Staff Report

File #: LN-659

PLANING AND ZONING BOARD
Meeting Date: NOVEMBER 20, 2024

Text Amendment to Zoning Code related to the height and location of Gazebos/Tikis/Chickees and the required Rear Yard Corner Triangle

Figure 155.5302.D.5.a: Rear yard corner triangle

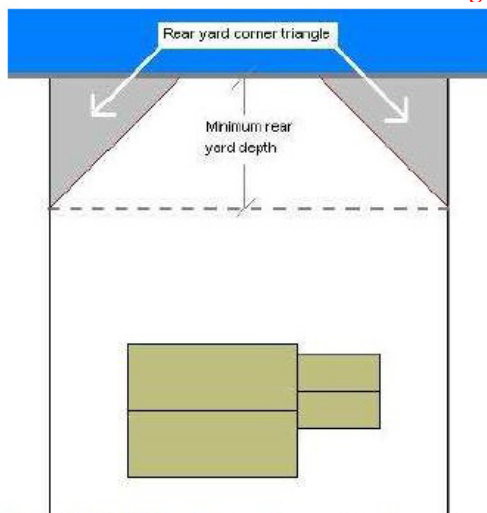
Staff proposes to eliminate all rear yard corner triangle standards (remove fence and vegetation transparency, no structures or obstructions over 3 feet in height) and to create an exemption for Gazebos/Tikis/Chickees to allow them within 3 feet of a rear lot line abutting a waterway or canal. Such structures are already permitted within 3 feet of an interior side lot line when a six-foot-high solid fence exists; otherwise, a 5-foot setback is required. The overhang of the Gazebo/Tiki/Chickee roof shall not be permitted within 1 foot of the interior side setback. This way, there is no scenario where the roof of the structure is 0 feet from the shared property line. Additionally, Staff proposes to modify the maximum height of the structure to 15 feet rather than the 10 feet that is required for a Gazebo or Tiki. A true chickee hut can have a height of 15 ft. But as is often the case, a chickee “becomes” a tiki over time when plumbing, electrical and/or other non-native materials are added. In such cases, the height is then required to be reduced to 10 feet, creating additional code compliance issues. Therefore, a uniform height requirement of 15 feet is proposed.

Fences will now be permitted to run the length of the property line at a uniform height (up to 6 feet) without the required transparency. Additionally, landscaping may be permitted as well. The intent of the Rear Yard Corner Triangle is to preserve the view of a neighbor's property across the subject property when located against a waterway or canal. While this change will not affect the view of a property across their own property line, it may reduce the visibility across a neighbor's.

~~a. Within Rear Yard Corner Triangle~~

~~—Except as otherwise provided in subsection e below, where the rear lot line abuts the canal or waterway, no fence, wall, or other obstruction greater than three feet high shall be located within the triangular land area formed by the intersection of the rear lot line with an interior side lot line not abutting a canal or waterway—with two sides of the triangle running along the rear and interior lot lines and being equal in length to the minimum rear yard depth, and the third side being a line connecting the ends of the other two sides—provided that a fence in such area may be as high as 42 inches if it is 66 percent see-through and may be as high as six feet if it is at least 75 percent see-through. (See Figure 155.5302.D.5.a: Rear yard corner triangle.)~~
